PRODUCT SAFETY RECALL

SUBJECT: Transmission Shift Cable Fracture

MODELS: 2004-2007 Chevrolet Malibu Maxx
2004-2008 Chevrolet Malibu
2005-2008 Pontiac G6
2007-2008 Saturn AURA
Equipped with 4-Speed Automatic Transmission (ME7/MN5)

The Service Procedure section in this bulletin has been revised. A park lock cable inspection has been included in the service repair. Please discard all copies of bulletin 14152B.

2269484

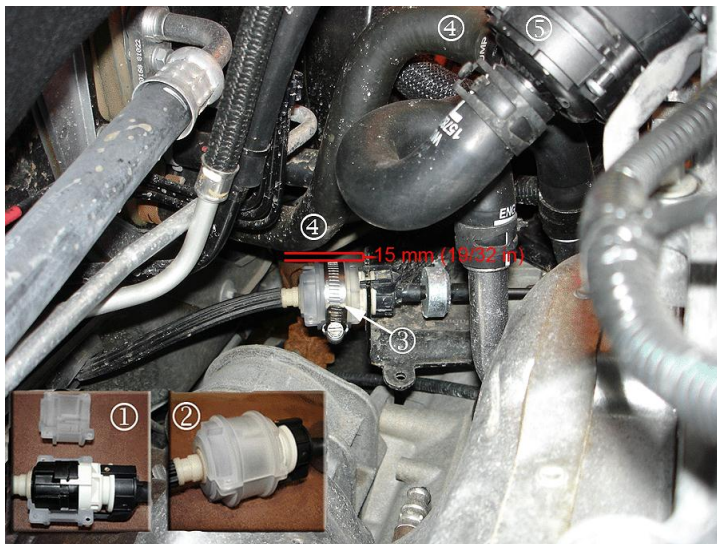
- (1) Clam Shell in Two Pieces
- (2) Clam Shell Around Shift Cable Locking Tabs
- (3) Clamp on Clam Shell
- (4) Inlet Coolant Hose and
- (5) Heater Cooler Pump.

5. Install the clam shell (1) (2) over the shifter cable locking tabs.
6. Install the service clamp over the clam shell (3). Position the clamp fastener head away from the inlet coolant hose (4). **Tighten the clamp to 4 N·m (35 lb-in).**
7. Ensure that there is 15 mm (19/32 in) of clearance between the inlet coolant hose (4) and the clam shell (3). On hybrid equipped vehicles, it may be necessary to reposition the inlet coolant hose (4) to achieve the required 15 mm (19/32 in) of clearance. **To reposition the inlet coolant hose (4) on hybrid equipped vehicles, locate the heater cooler pump (5) and perform Steps 7.1-7.5.**

Caution: Do not kink or damage the inlet coolant hose (4) when repositioning the hose to obtain the 15 mm (19/32 in) clearance. To avoid damaging the hose clamp, use J-38185 or equivalent hose clamp pliers to loosen the hose clamp.

- 7.1. Remove the generator control module cover. Refer to *Generator Control Module Cover Replacement* in SI.
 - 7.2. Using J-38185 or equivalent hose clamp pliers, loosen the inlet coolant hose (4) connected to the heater cooler pump (5). Note the location of the clamp on the inlet coolant hose (4).
 - 7.3. Rotate the inlet coolant hose (4) clockwise until 15 mm (19/32 in) of clearance between the inlet coolant hose (4) and clam shell (3) is achieved.
 - 7.4. Ensure that the inlet coolant hose clamp is secure on the inlet coolant hose (4) in the production location.
 - 7.5. Install the generator control module cover. Refer to *Generator Control Module Cover Replacement* in SI.
8. Close the hood.
